From: Sparkes, Bill TRAN:EX
Sent: Thu, December 7, 2006 2:51 PM
To: Peterson, Joe J TRAN:EX
Subject: RE: King file - Kaleden 17486

To: Bill Sparkes, Joe Peterson
Copy: Randy Kowalchuk, Jim Morrison
Date: December 18, 2006
From: Brad Elenko
Subject: Naramata Benchlands PLA – Follow-up

Re: Proposed Subdivision – Sublot 14, D.L. 2711, SDYD, Plan 1190 except
Plans A62, 29843, 38736, KAP44343, KAP45544, KAP46231,
KAP54137, & KAP57167
Your File – 02-008-17281

Proposed Access To Strata Road - Slate Place

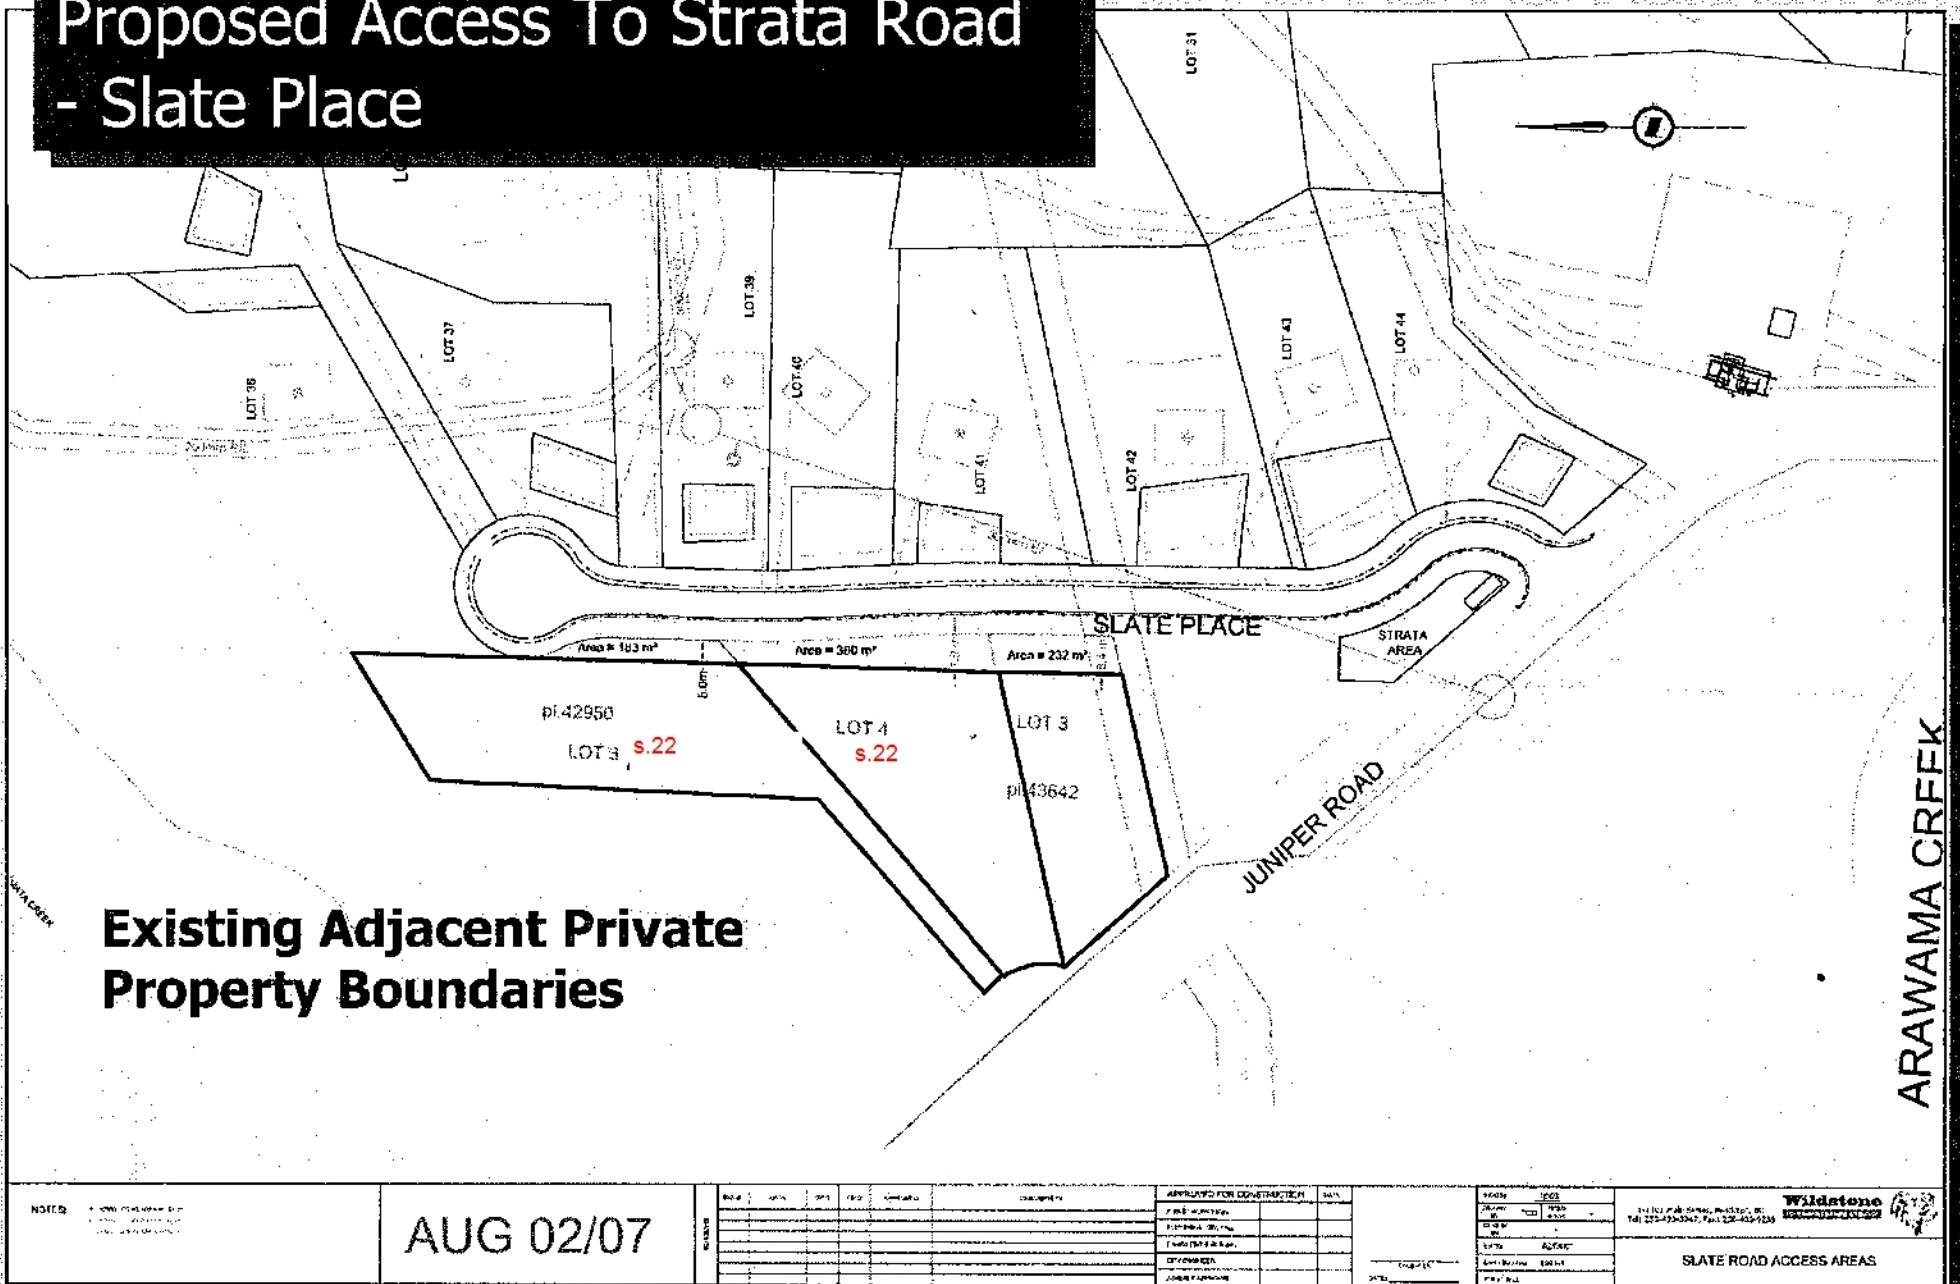
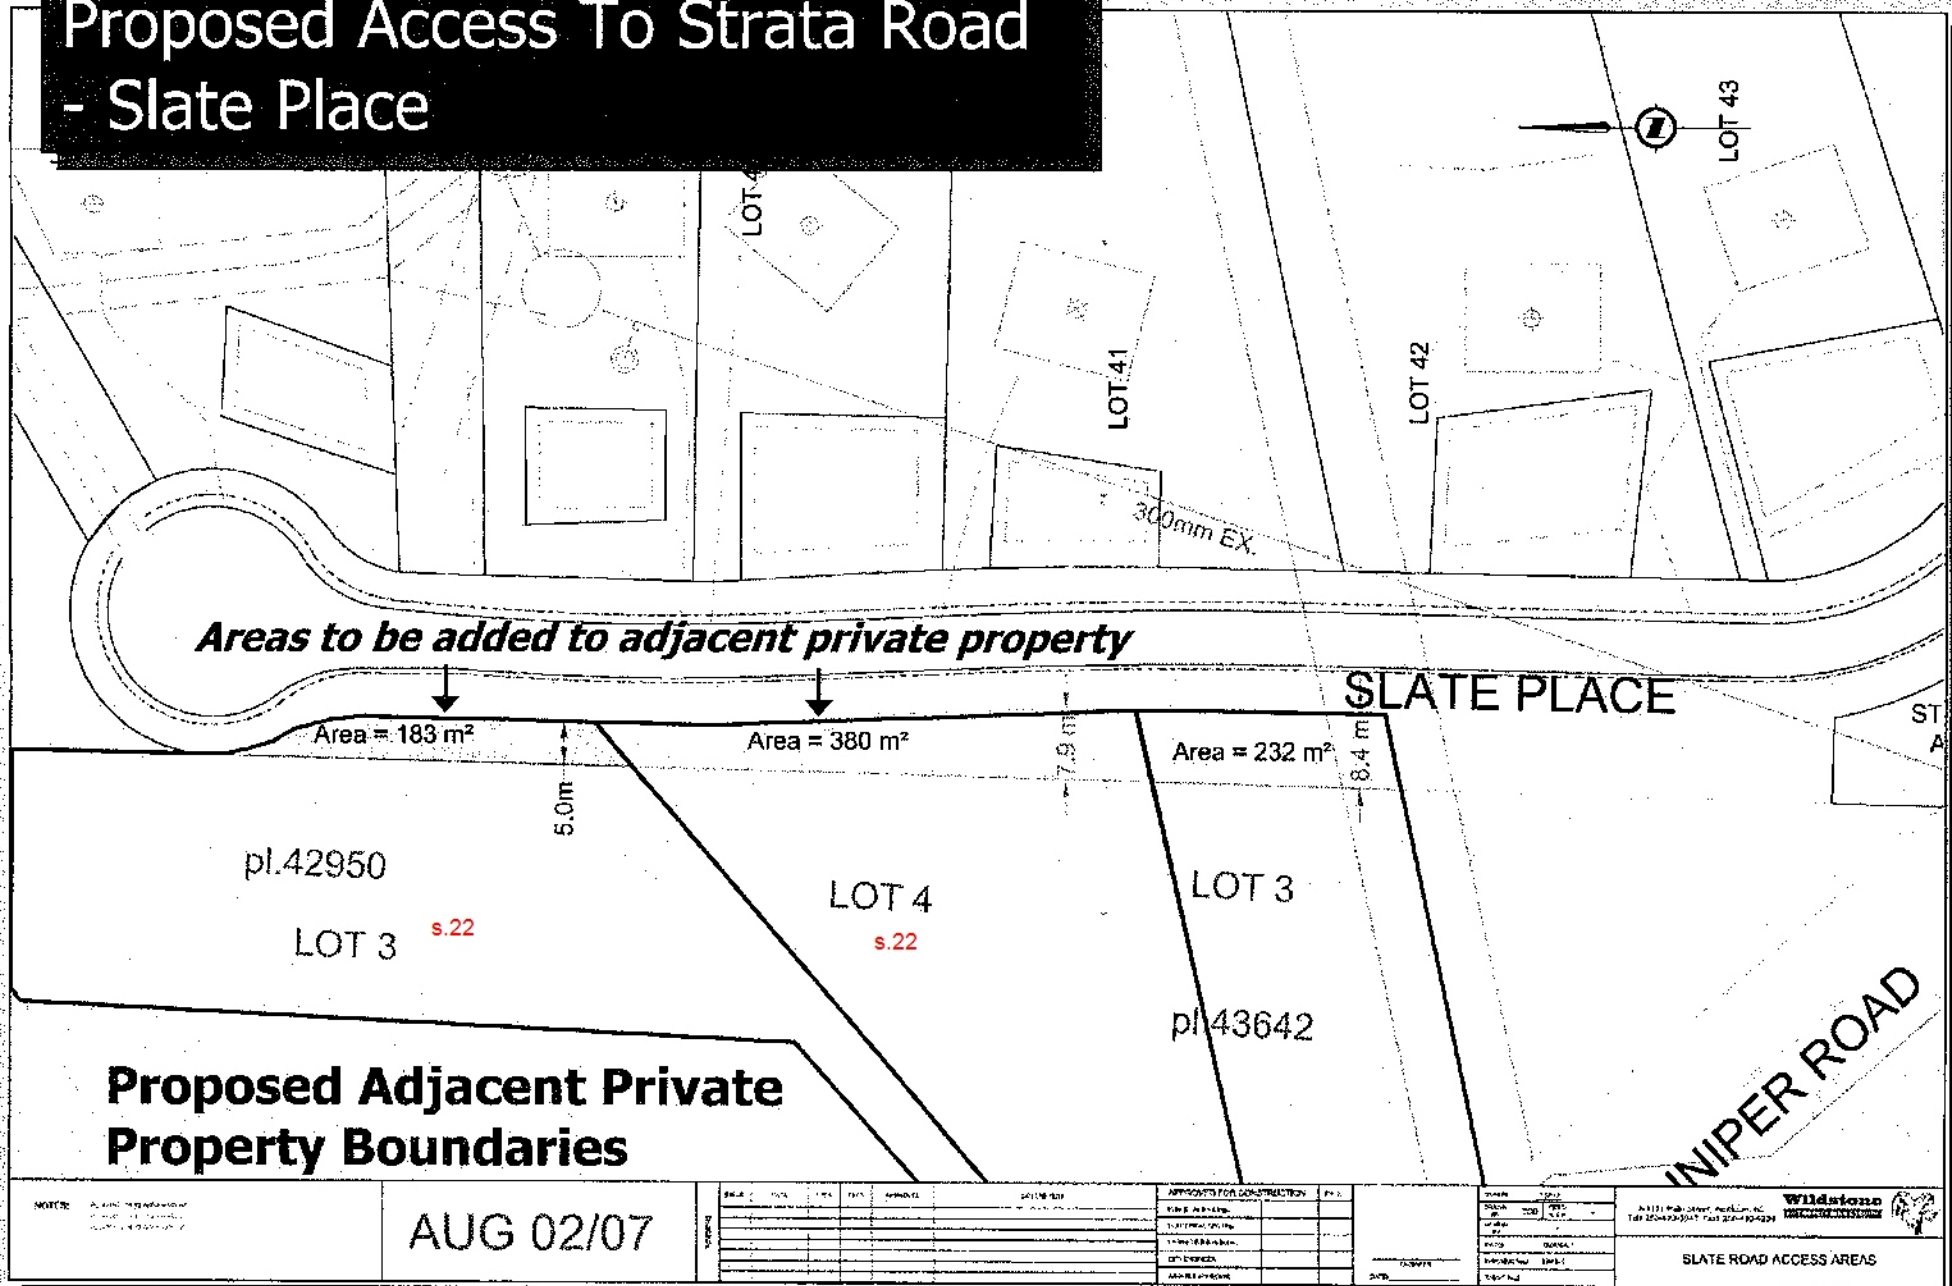
It is proposed that a strip of land be subdivided from the property adjacent to the east side of lots 8 to 12, and that the property be added to the StoneBrook subdivision and designated as common property. The narrow strip of land adjacent to lots 9, 10, 11, and 12 will be common property used for alternative access to these proposed lots.

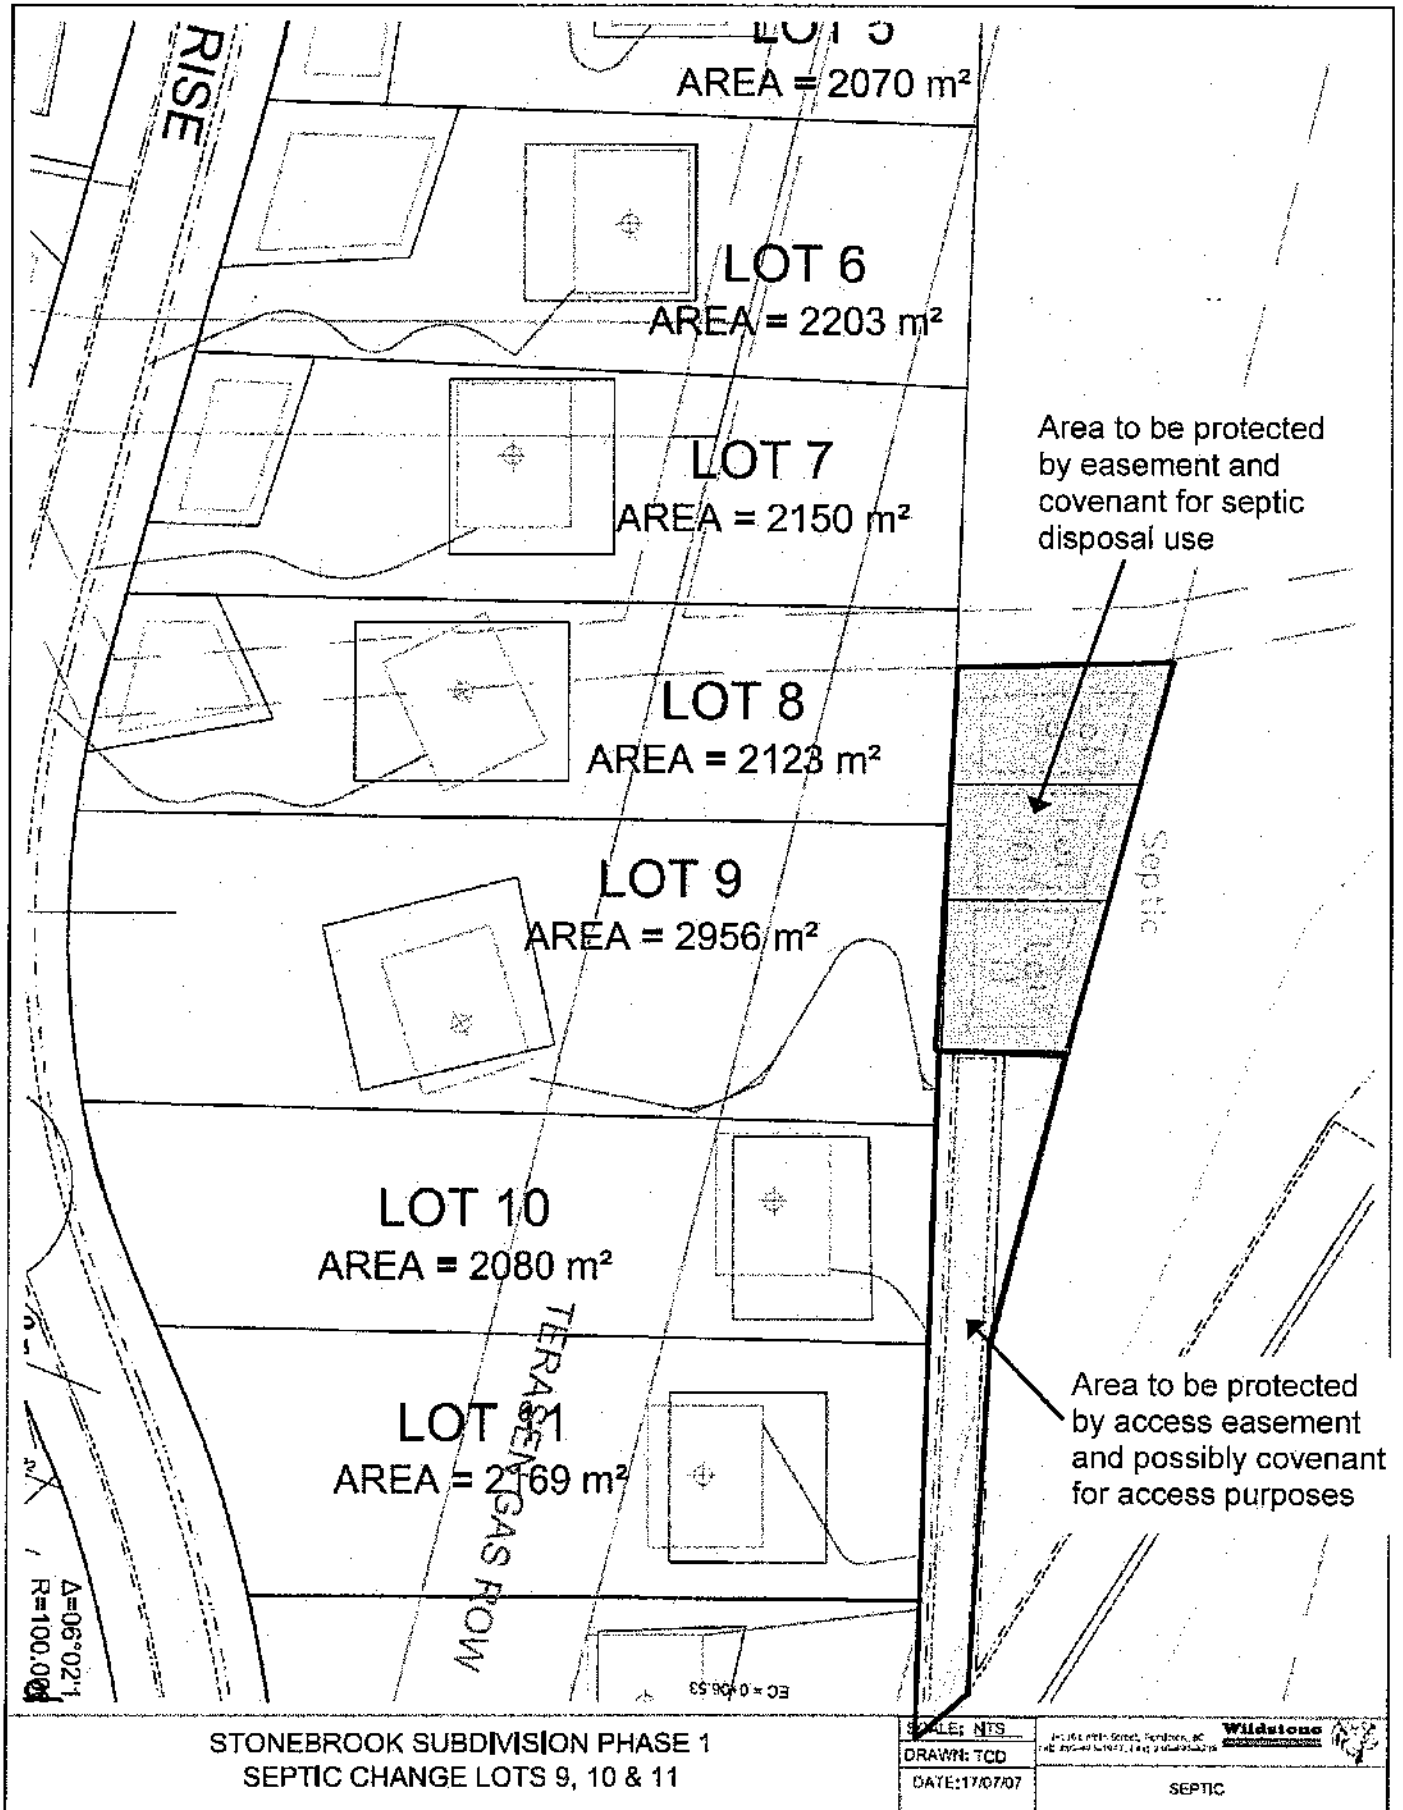
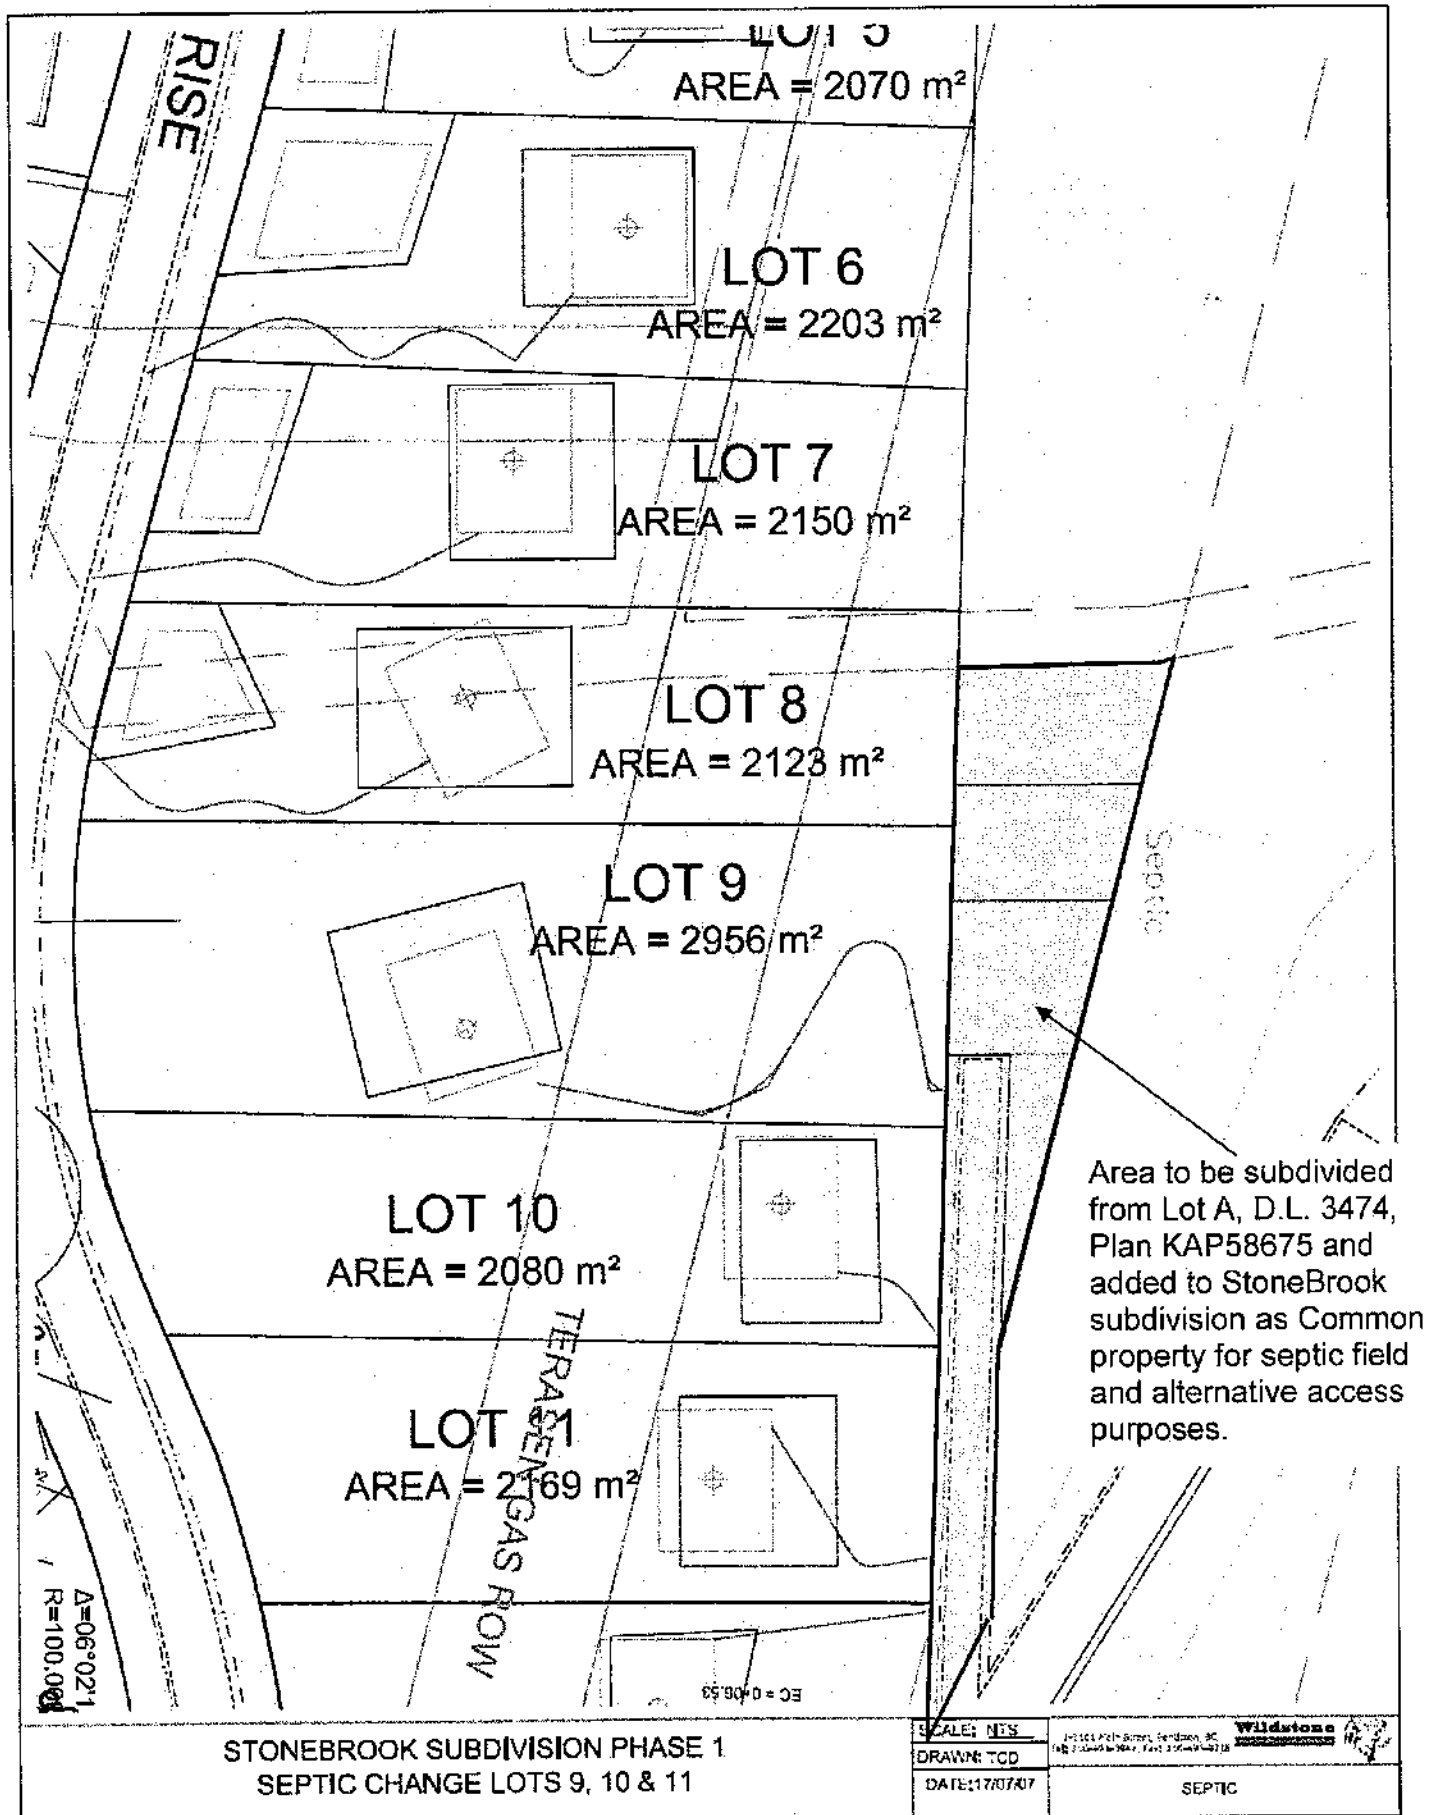
As noted on the attached drawing, the area of the three proposed engineered septic disposal areas is located immediately north of the private driveway. It is proposed that the area for the three septic disposal areas would be protected by an easement to allow access to the area for construction and maintenance of the septic disposal areas as well as a covenant to restrict the use of the property to septic disposal areas for the adjacent three lots. To ensure the delineation and protection of the three proposed septic disposal areas, the lands could be enclosed by a fence to ensure the areas are physically protected and maintained for the sole purpose of septic disposal for the three adjacent lots.

Provided below is a plan which shows the entire StoneBrook subdivision as well as a plan which specifically shows the three lots which can not accommodate on-site septic disposal and the proposed septic disposal areas on the adjacent property which is also owned by the developer of the StoneBrook subdivision.
